METROPOLITAN GOVERNMENT OF NASHVILLE AND DAVIDSON COUNTY

Metropolitan Historic Zoning Commission
Sunnyside in Sevier Park
3000 Granny White Pike
Nashville, Tennessee 37204
Telephone: (615) 862-7970
Fax: (615) 862-7974

STAFF RECOMMENDATION 2312 White Avenue March 18, 2015

Application: New construction – addition; Setback determination
District: Woodland in Waverly Historic Preservation Zoning Overlay
Council District: 17
Map and Parcel Number: 10514023200
Applicant: Josh Spence, Kennon Calhoun Workshop
Project Lead: Melissa Baldock, melissa.baldock@nashville.gov

Figure 2. Window proposed to be altered

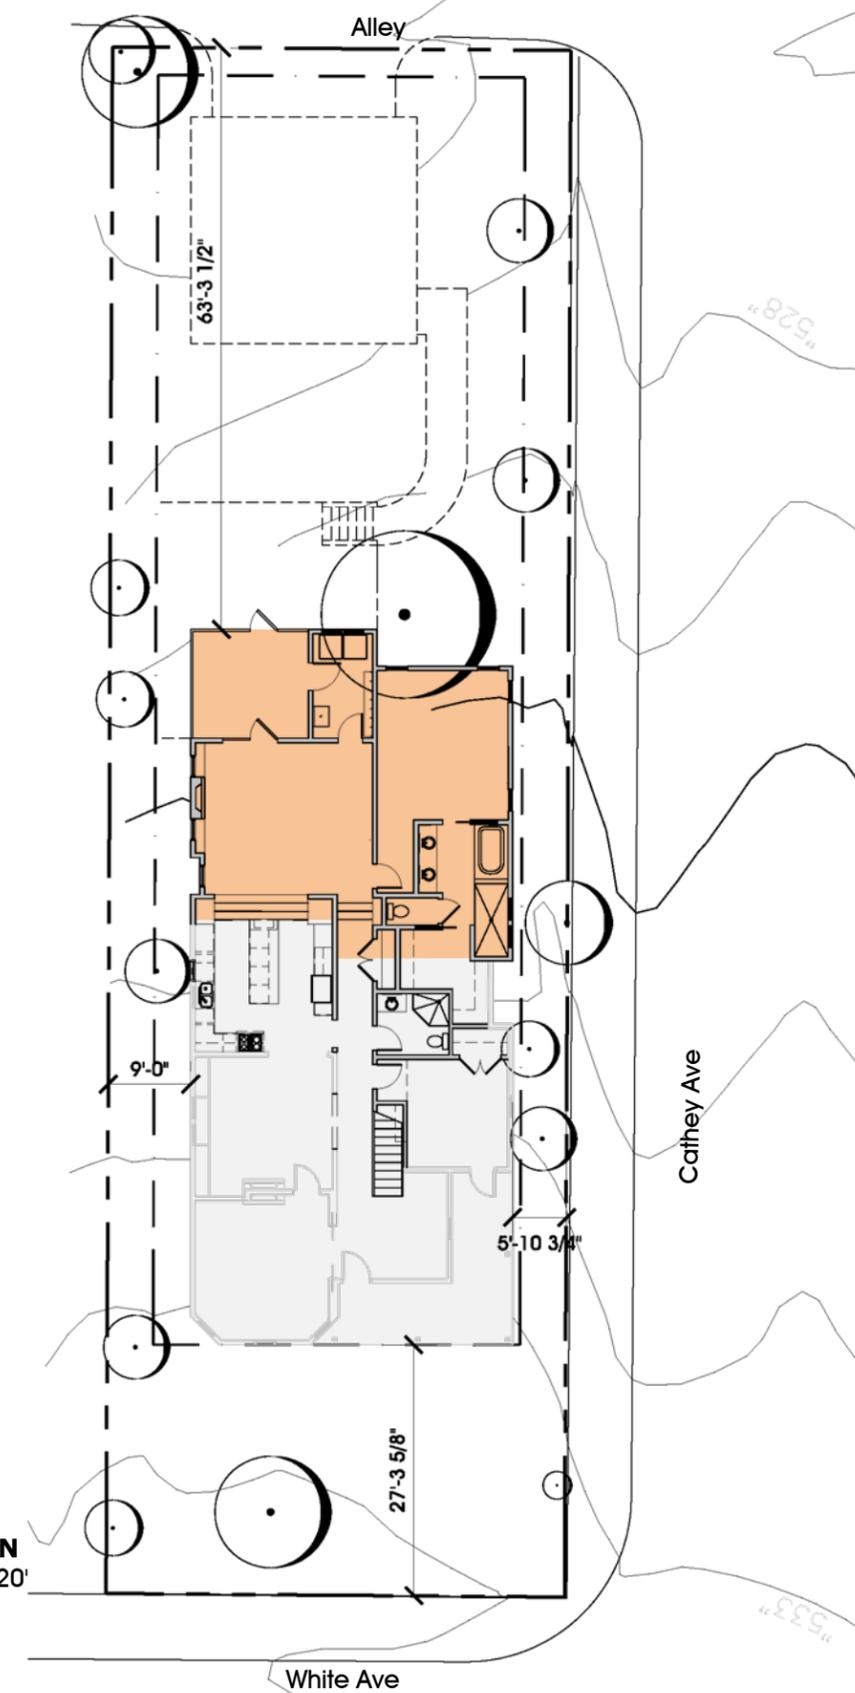
The applicant is proposing two alterations to the historic house. On the north/left elevation, the applicant is proposing to alter an historic window opening towards the back of the house (Figure 2). Section II.B.3.a. of the design guidelines states, “The original size and shape of windows should be maintained.” Staff therefore finds that altering this window opening does not meet the design guidelines.

1. All existing window openings, including the window on the back of the north/left façade, remain as is;

Figure 3. Portion of the rear to be demolished.

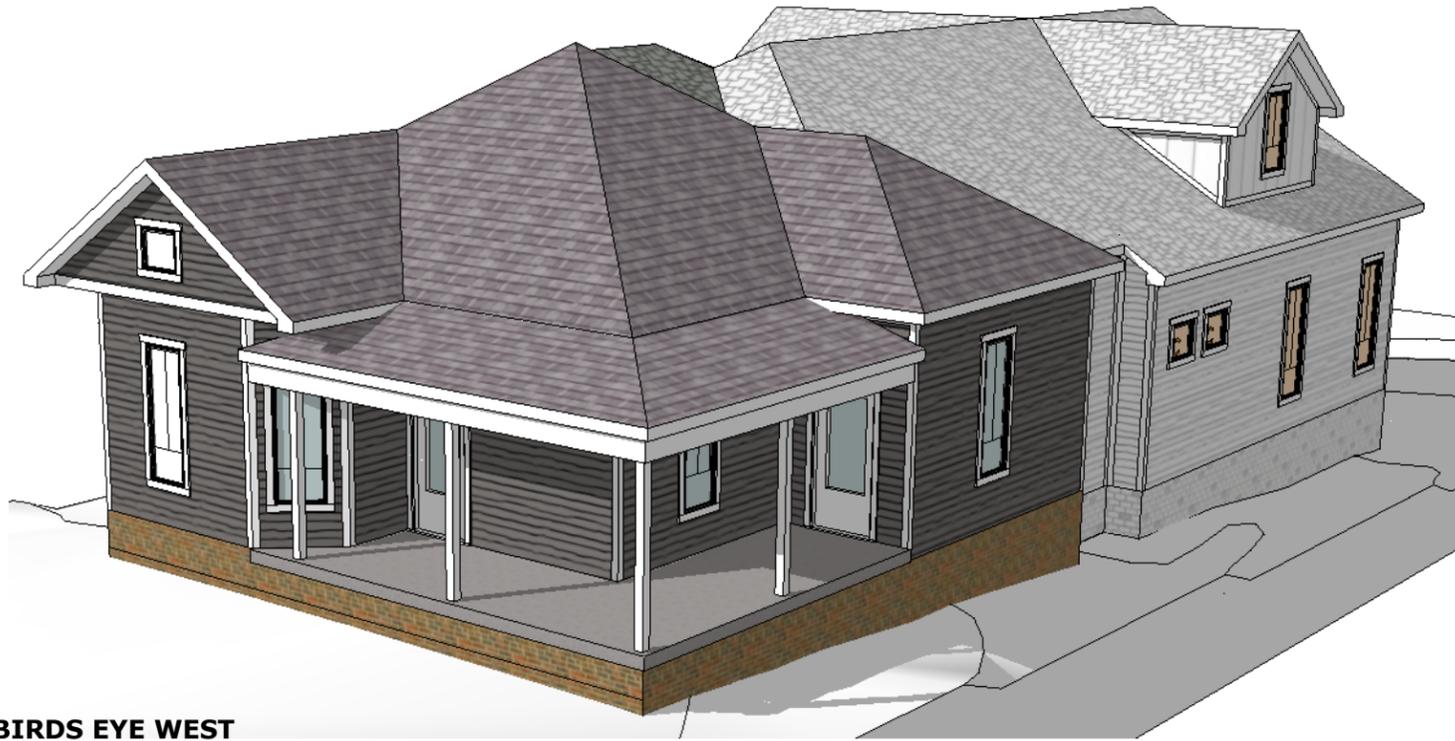
Partial Demolition: The applicant is proposing to demolish a portion of the rear of the house (Figure 3). The area to be demolished has a shed roof that breaks the eave of the rear façade. It is possibly a former porch that was enclosed. Staff finds that this portion of the house, with its lower shed roof form, does not contribute to the overall historic character of the house and that its demolition would not significantly impact the house's historic integrity. Staff therefore finds that the demolition of the rear portion of the house meets the design guidelines' Section V.B.2. for appropriate demolition and does not meet Section V.B.1. for inappropriate demolition.

SITE PLAN
scale: 1" = 20'

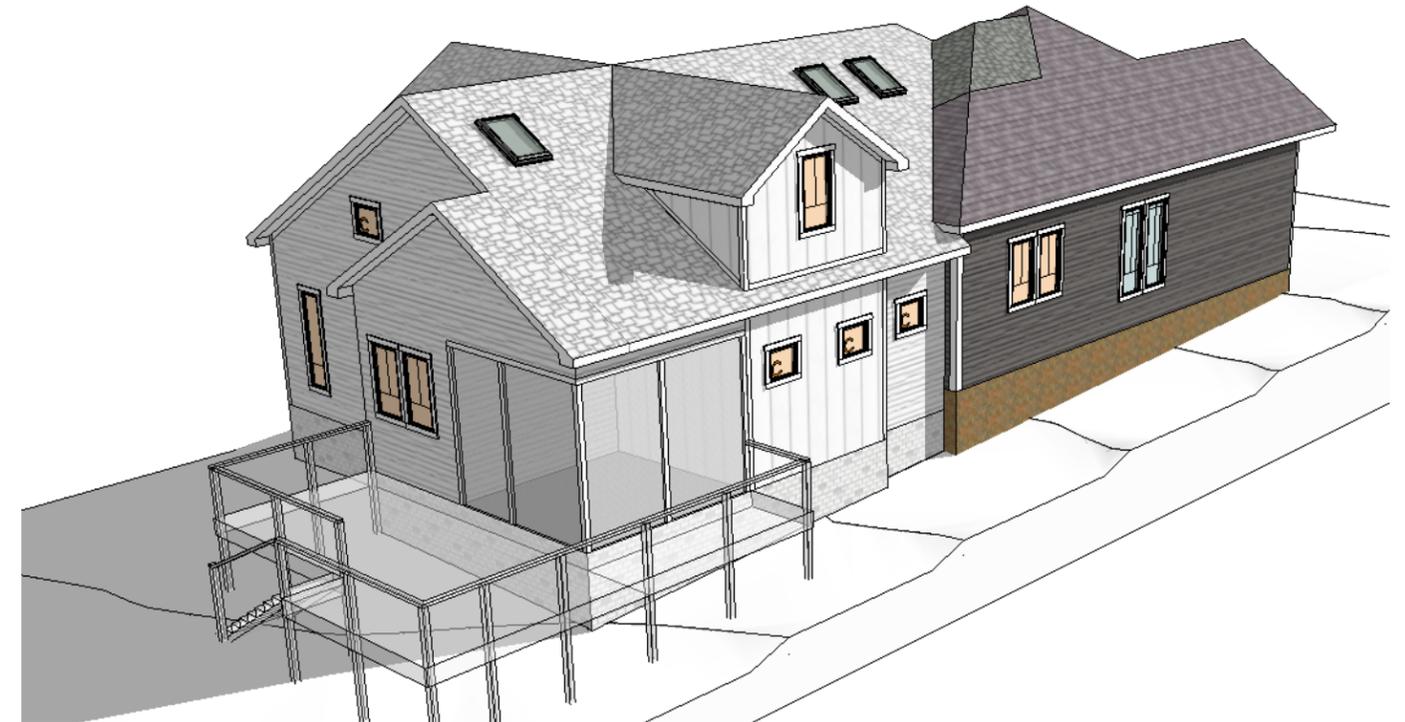
A future deck is planned and shown on the elevations, but not the site plan. Staff recommends approval of the deck with the conditions that the materials are administratively approved and the deck does not extend beyond the side wall of the house.

Outbuilding: No outbuilding is proposed as part of this application. The site plan includes a dotted line indicating the site of a potential future garage, but that garage is not currently under the Commission's consideration.

NORTH ELEVATION
scale: 1/8" = 1'-0"

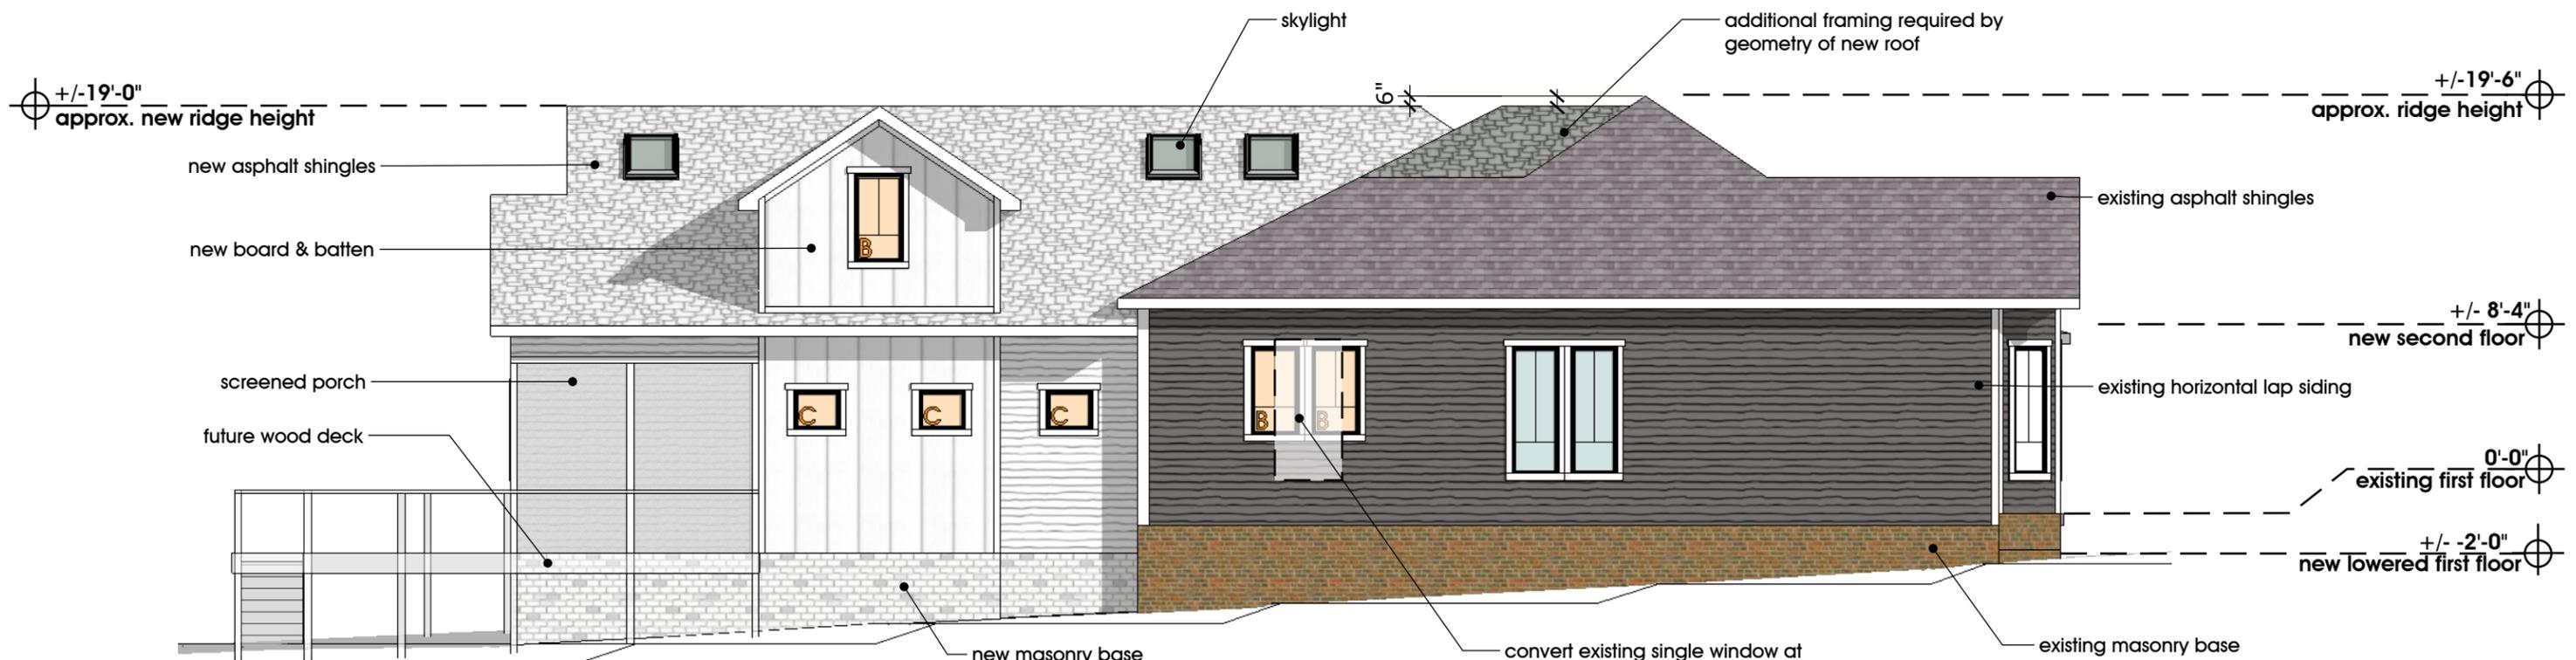
The applicant is also altering the historic roof form in order to tie the addition into the historic roof. Staff recognizes that hipped roofs with multiple forms like this roof can be difficult to add on to; however, the applicant’s proposal involves eliminating two of the historic house’s ridges on the north/left elevation. The new roof form raises the height of the back gable’s ridge and eliminates the most of the distance between the taller central hip form and the lower back hipped roof. With this proposal, this portion of the historic roof form would be permanently and irreversibly altered. Section II.B.1.a. of the design guidelines states, “a. Original roof pitch and configuration should be maintained.” Staff

therefore finds that the proposed alteration to the roof form on the north/left elevation does not meet the design guidelines. Staff asks that a condition of approval be that the addition's roof tie into the existing roof in a manner that preserves the historic roof form.

Roof Form: The historic house has several hipped and gable forms, all with pitches of approximately 7/12. As mentioned under the "Alterations to the Historic House" section, the addition's roof ties in inappropriately to the historic house's roof form on the north/left elevation. The addition's primary roof form is a combination of a hip and a gable with a slope of 7/12. The addition includes two gabled dormers, both with 8/12 pitches. The dormer on the south/Cathey Street elevation is set back two feet (2') from the wall below, but the dormer on the north/left elevation is not setback from the wall below. Staff asks that a condition of approval be that the dormer on the north/left elevation be setback two feet (2') from the wall below.

With the conditions that the addition ties into the historic roof in a manner that preserves the historic roof form and that the dormer on the north/left elevation be set back two feet (2') from the wall below, staff finds that the addition's roof form meets Sections III.B.1. and III.B.2.e. of the design guidelines.
